**FINAL ENVIRONMENTAL IMPACT REPORT AND
SUPPORTING DOCUMENTATION**

RANCHO SANTA FE ROUNDABOUTS PROJECT

County Project No. 1009758

- List of Commenters, Letters of Comment, and Responses to Comments on the Draft Environmental Impact Report

Figure 1.5
Paseo Delicias/El Montevideo/La Valle Plateada Intersection

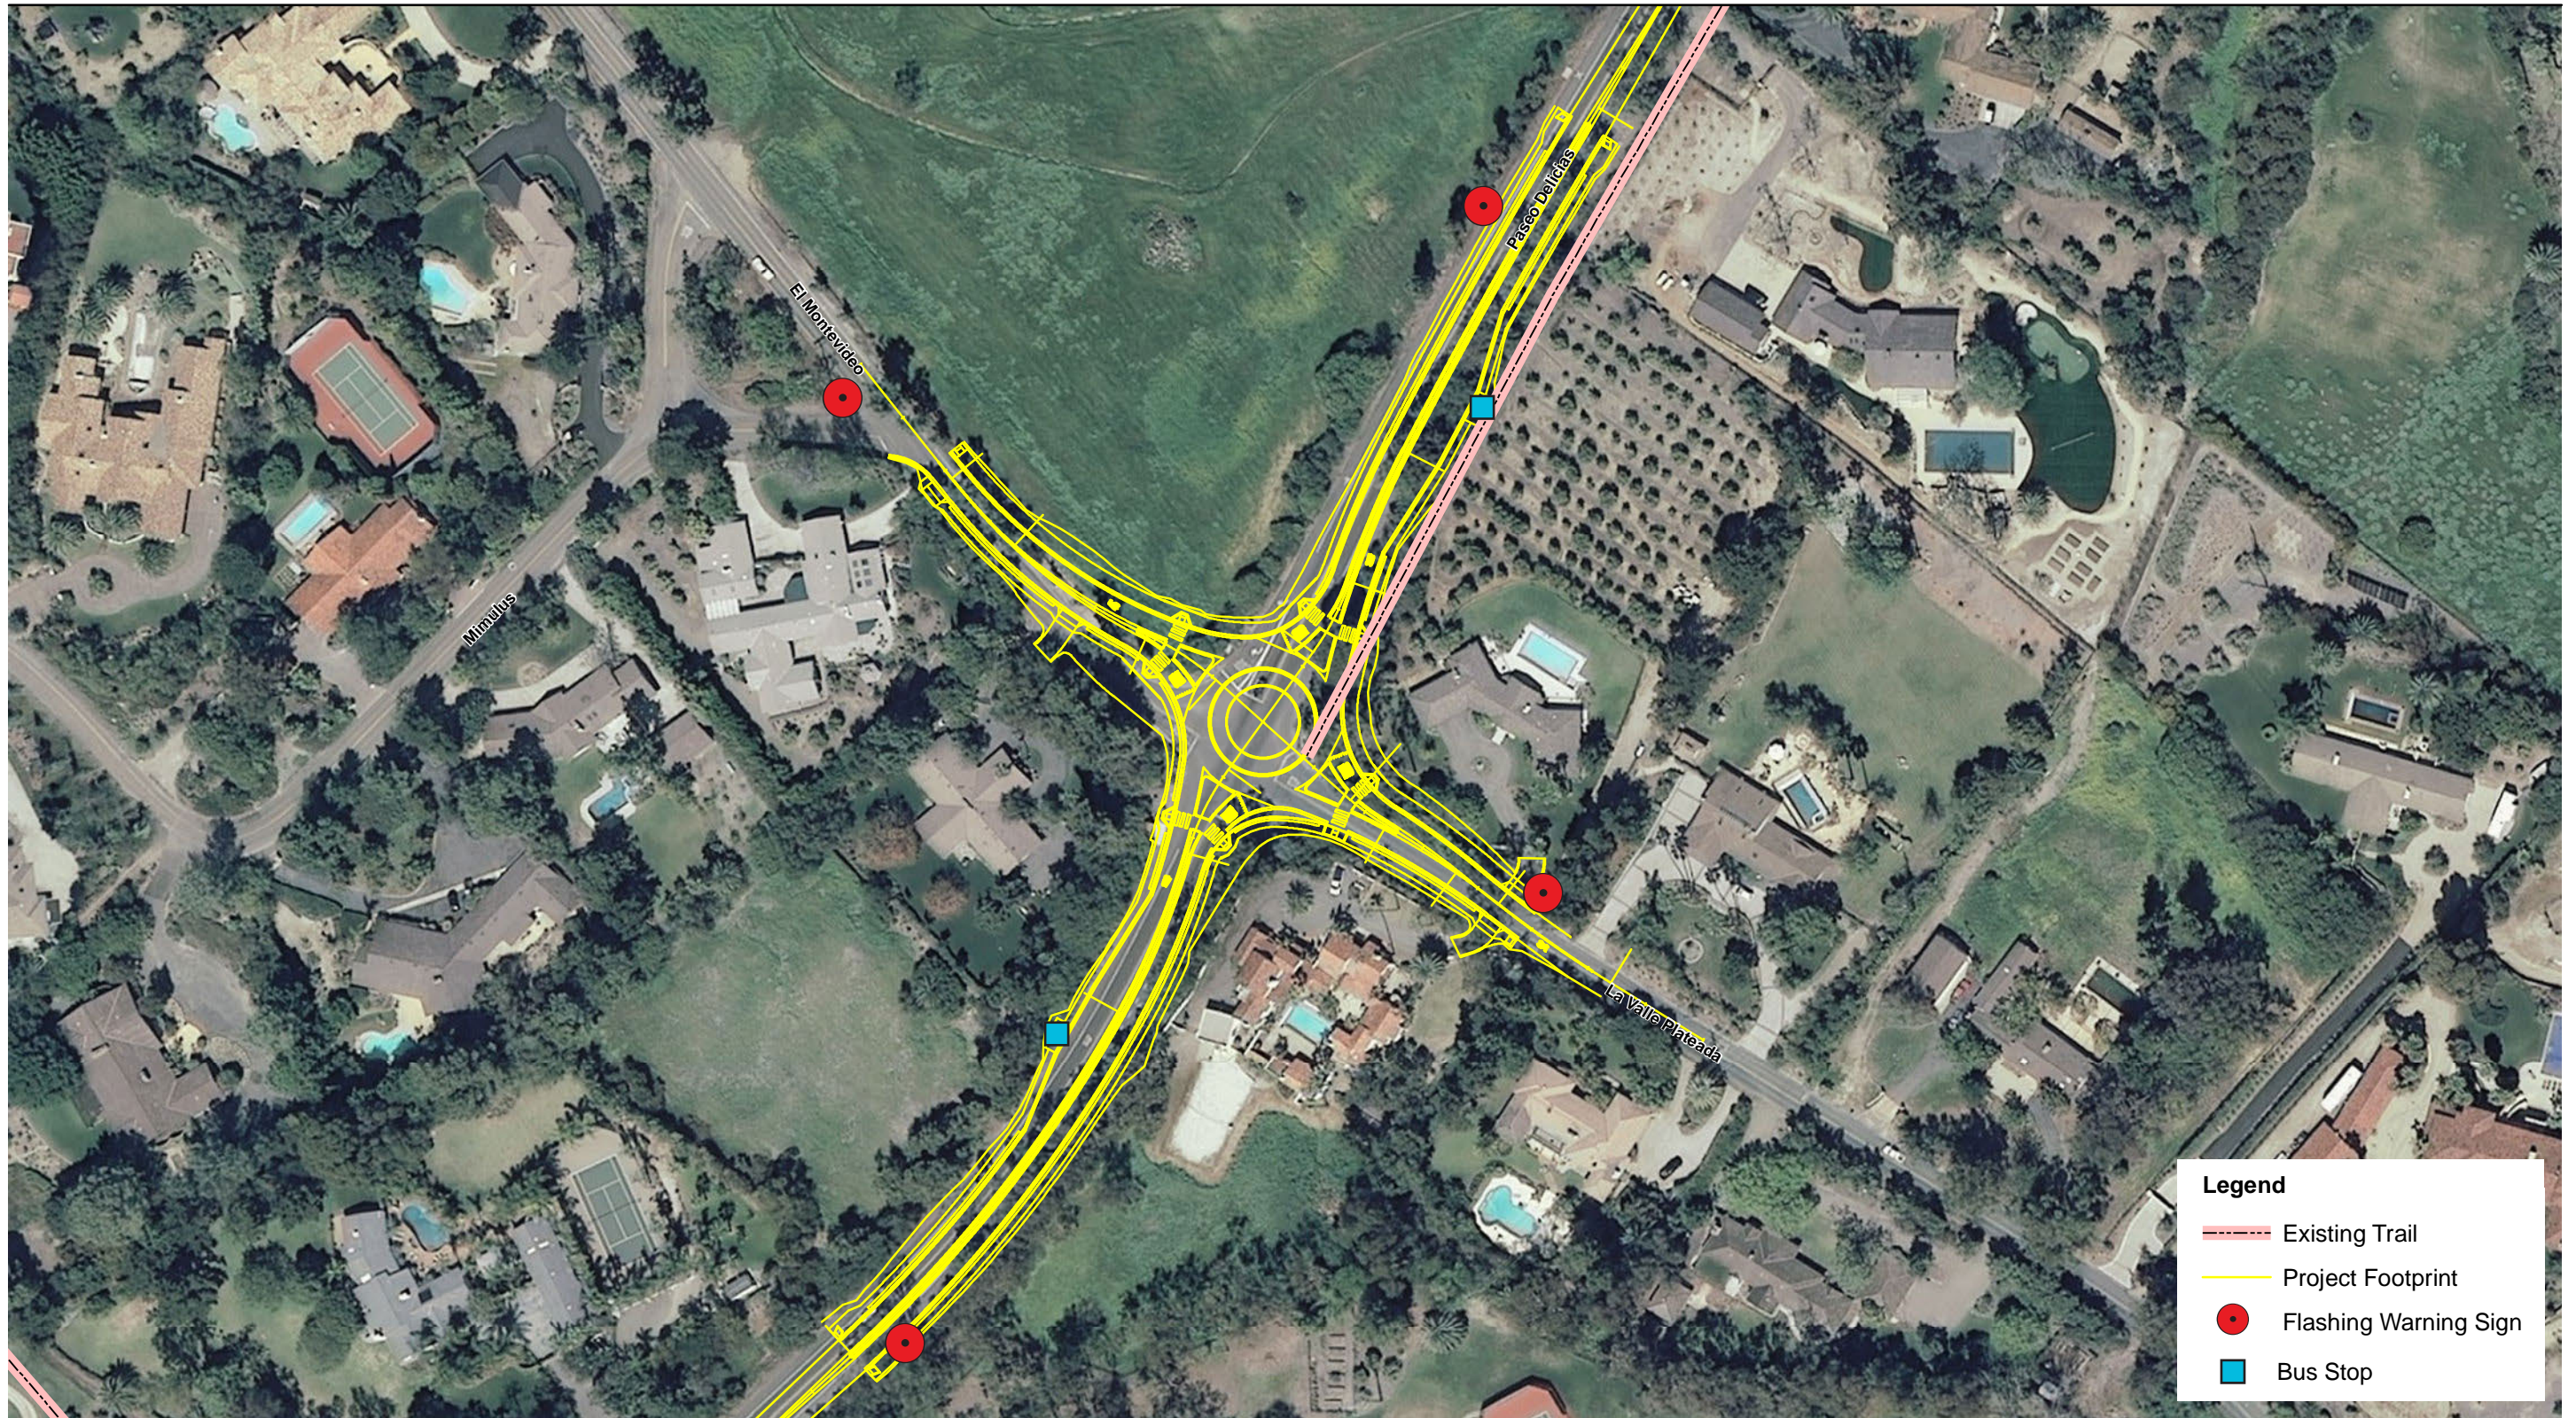
- F-7 3. Drawing needs to show the left-turn pockets at Las Colinas and Paseo Delicias.
- F-8 Fig 1.5, p. 49. Paseo Delicias/EI Montevideo/La Valle Plateada: A desired trail should be shown in right-of-way (ROW) along NE side of EI Montevideo (Bunn property) - we have ridden there for decades. It could be shown as a dashed pink line. This trail connects trails to the north on EI Montevideo.

- F-8** Thank you for this comment. Trails depicted on the EIR figures are officially designated, constructed, and/or planned. The section of desired trail described by the commenter is not shown on the existing trails network map (Appendix L—Figure 5) and is not mapped as a designated trail (Appendix L—Figure 6) or otherwise mentioned in the Equestrian Usage Assessment Report; for these reasons, the described section of undesignated trail is not appropriate for inclusion on the EIR figures. However, the Equestrian Usage Assessment Report (Appendix L, page 22) explains that the Rancho Santa Fe Association is working to expand the official trail system by actively recording and seeking easements for undesignated trails. No changes were made to the EIR as a result of this comment.

Figure 4.1
Via de la Valle/La Fremontia Signalized Intersection

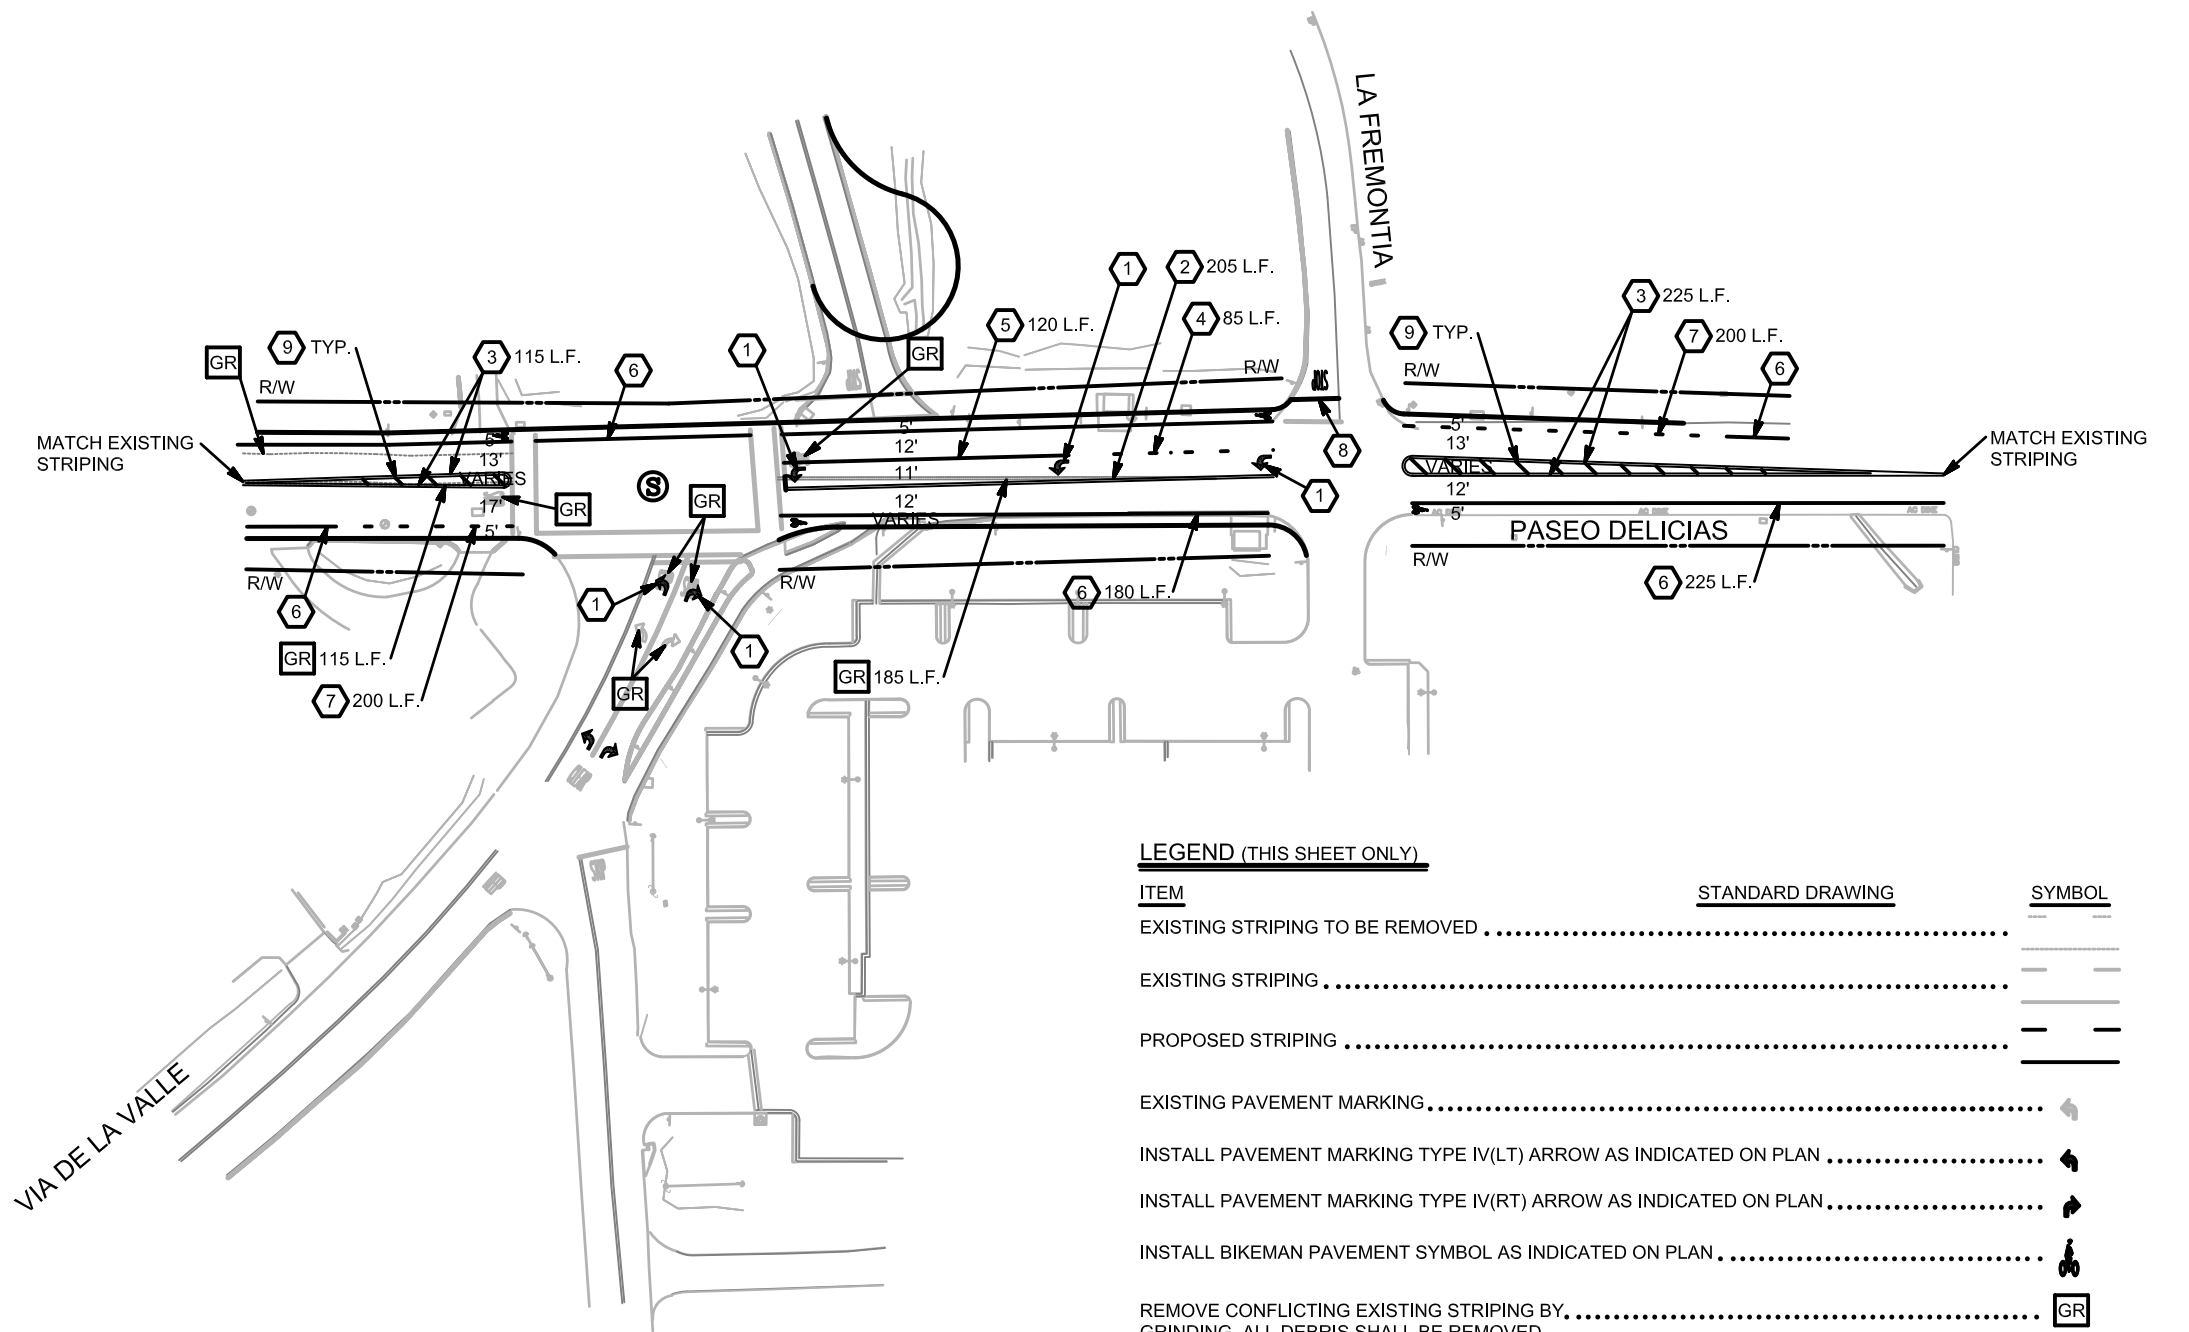
- F-15 Fig. 4.1, p. 269. Signalization Alternative: Via de la Valle/La Fremontia. Drawing should show existing trails and reference trails in the legend, including the trail on Las Colinas. Drawing should include 4 pedestrian/equestrian bi-level push button signal poles and LED-lit crosswalk at the Via de la Valle crossing; Las Colinas crossing needs LED crosswalk and push button poles, too. Both bus stops are in the travel lane; relocate them. Need analysis of right and left turn pockets in regard to stacking

- Regarding the request to show a pedestrian and equestrian on the simulations, please refer to response to comment F-1.
- F-15** Thank you for this comment. The purpose of Figure 4.1 is to provide a conceptual line-drawing of the basic features of the Signalized Intersections Alternative for this intersection. All features that are described in the project description for the Signalized Intersections Alternative would be part of the design if this alternative were chosen for implementation. Please refer to responses to comments F-3 and F-4 for additional discussion on the level of detail provided in EIR figures. No changes were made to the EIR in response to this comment.

Figure 4.2
El Montevideo/La Valle Plateada Signalized Intersection

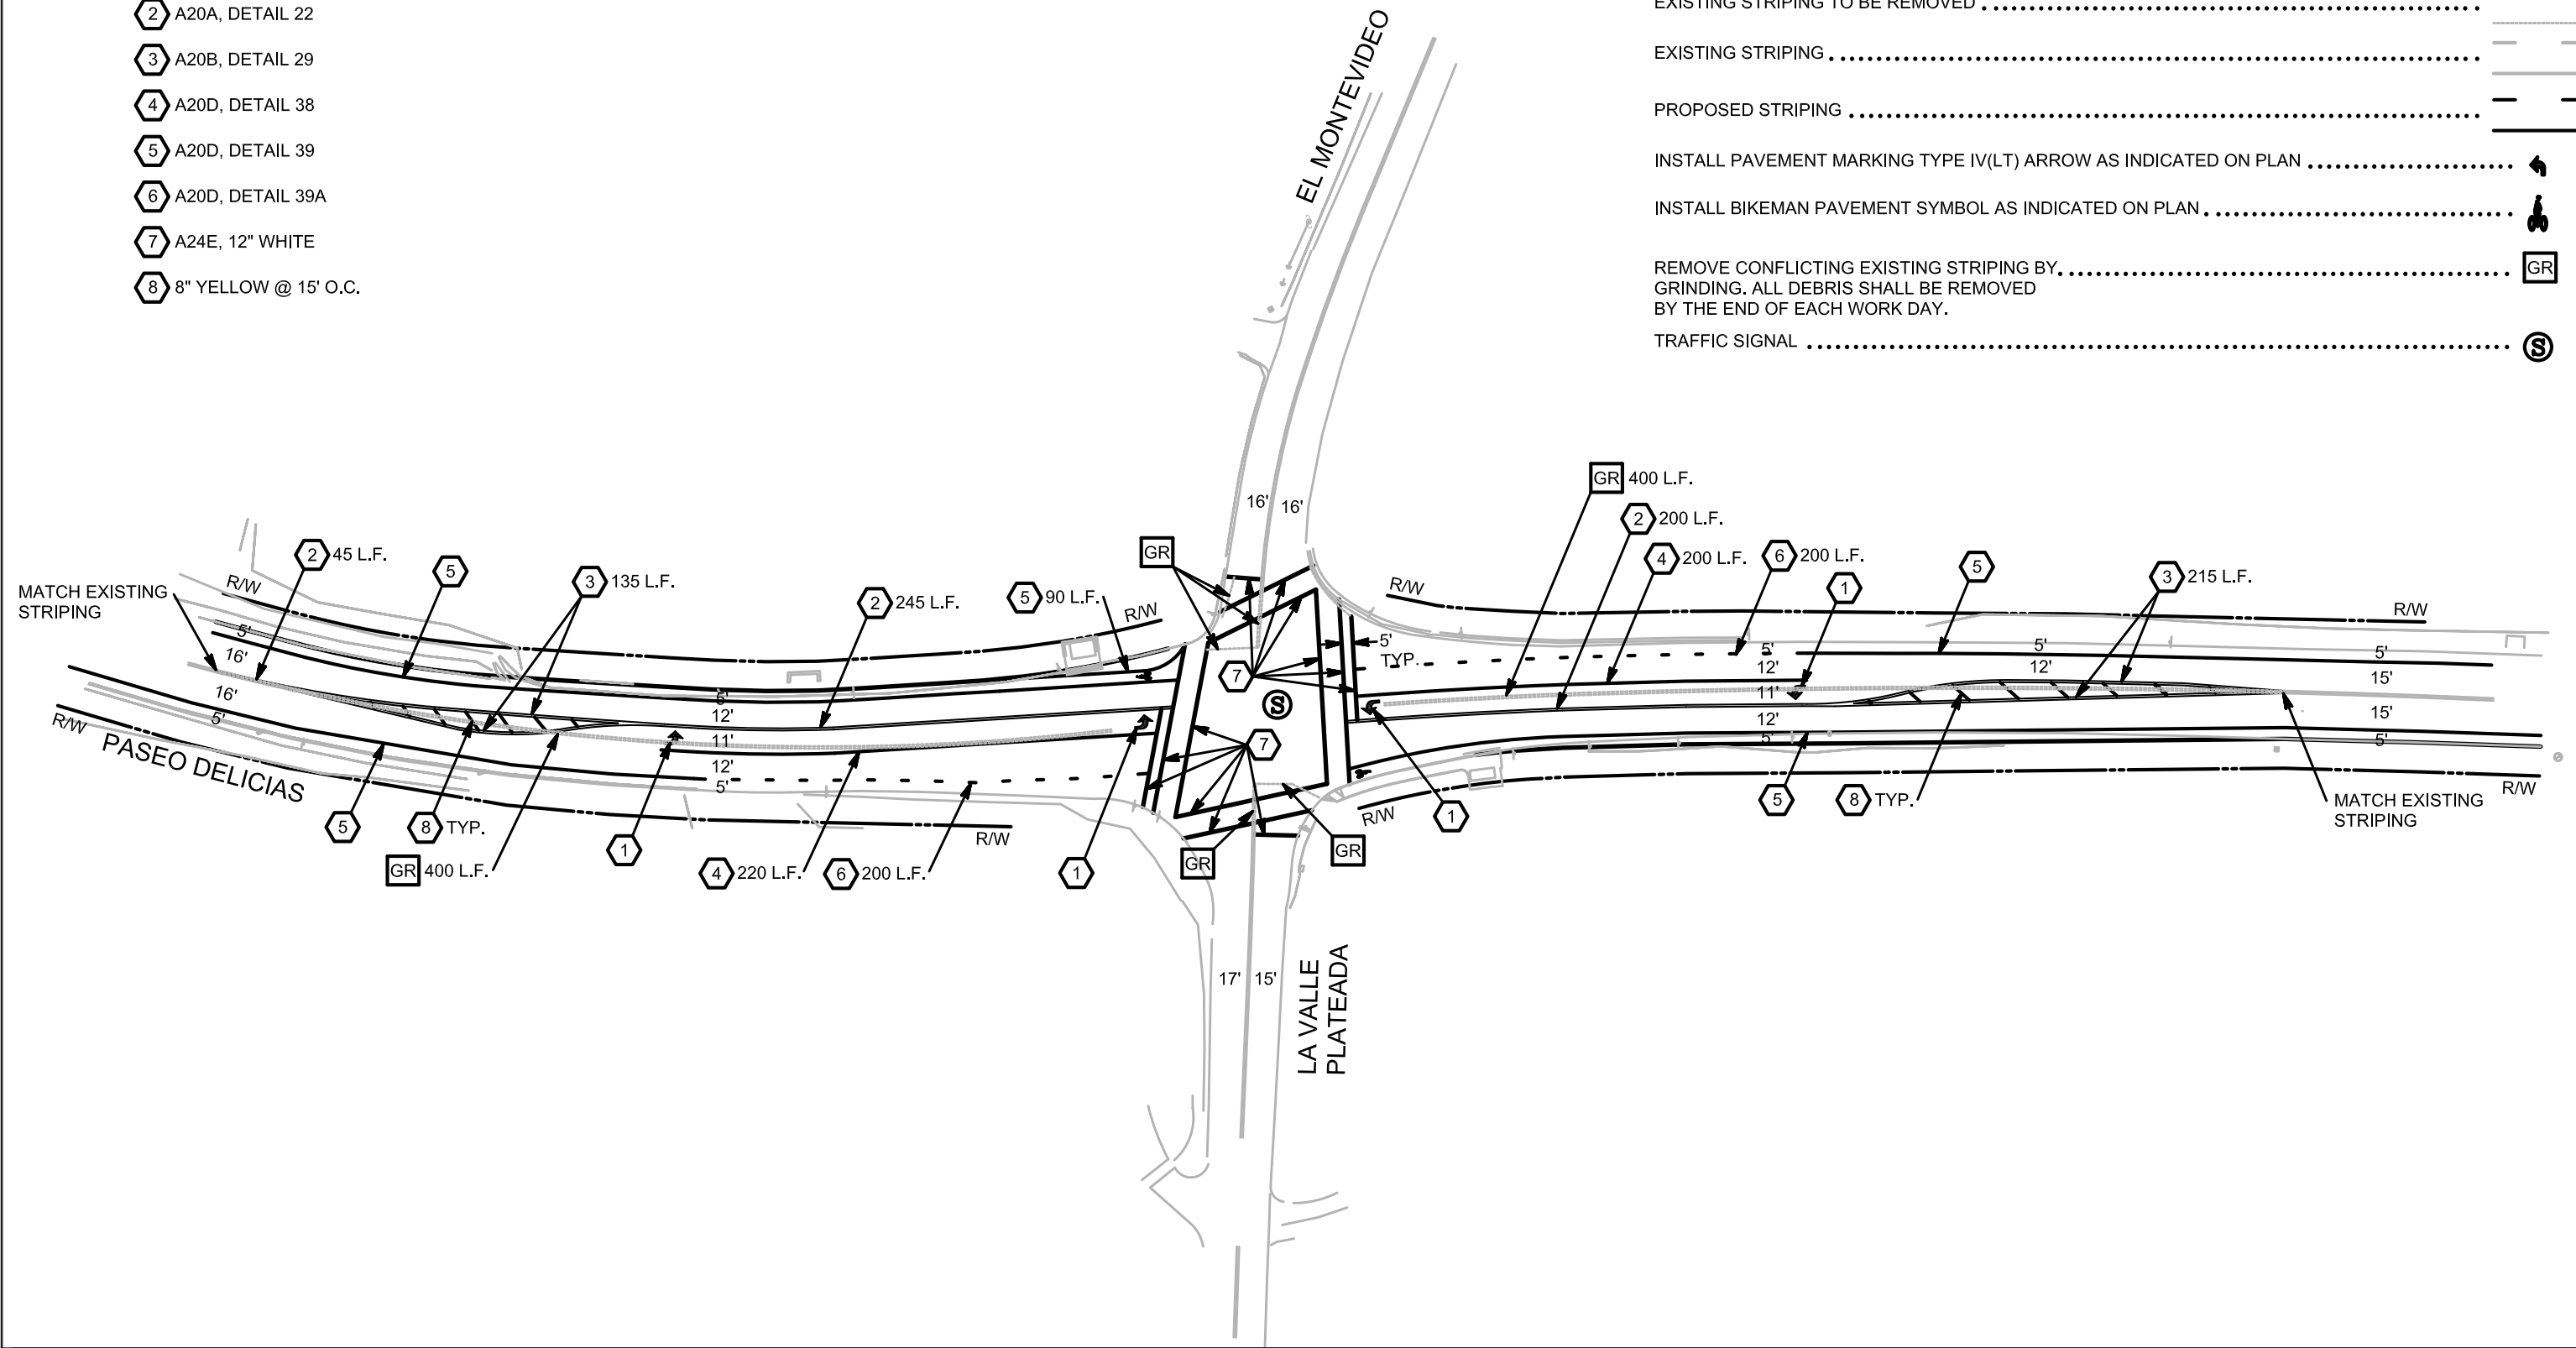
- F-16 Fig. 4.2, p. 271. Signalization Alternative: El Montevideo/La Valle Plateada. Add Trails to the legend. Show trail along La Valle Plateada that crosses to El Montevideo. Show Pedestrian/Equestrian bi-level push button poles and LED-lit crosswalks. No trail shown along SE side of Del Dios Highway that crosses to NE side of El Montevideo; add this trail to the rendering. There is desired trail along the NE side of Paseo Delicias that should be incorporated into the plan now; could show it as a dashed trail line. Bus stops are in the travel lane; relocate them. Need analysis of right and left turn pockets in regard to stacking
